FIELD CHANGE ORDER

Issued by: PMS DMC HamburgReference No.: FCO74200025Released by: T. FrenscheksignedDate: November 2004

OPTIMUS RAD / C

Replacement kit PCB "Current limiter"

1.2 INSTALLATION OF PCB "CURRENT LIMITER E(2)Q 100"

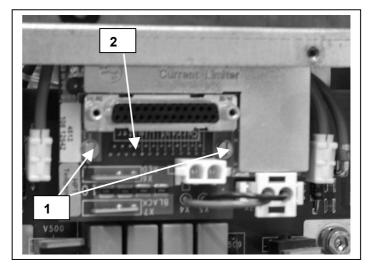
Symptom: Sporadic errors in the HV and the power circuit, such as 02XX

Cause : Soiling of the pins of connector X1 of the current limiter

Remedy : Exchange of PCB "Current limiter"

- Switch OFF the generator before starting any work.
- Open the generator cabinet.
- Turn OFF ENF1.
- Open the converter cover EQ and, when present, E2Q.
- Remove EQ 100E X2 (1)
 (and, when present, E2Q 100E X2).
- Remove EQ 100E X1 (2) (and, when present, E2Q 100E X1).
- Remove EQ 100 X2 (3) (and, when present, E2Q 100 X2).
- Remove EQ 100E X6 (4) (and, when present, E2Q 100E X6).
- Remove EQ 100E X7 (5) (and, when present, E2Q 100E X7).
- Remove the two screws of PCB "Current limiter" EQ 100E (1) (and, when present, from E2Q 100E).
- Remove PCB "Current limiter" EQ 100E (2) (and, when present, E2Q 100E).
- Install the new PCB "Current limiter" EQ 100E at EQ 100 X1 (and, when present, at E2Q 100 X1).
- Fasten the new PCB with the two screws formerly removed.
- Reestablish all connections formerly removed at their original positions (see service manual binder Converter R/F).
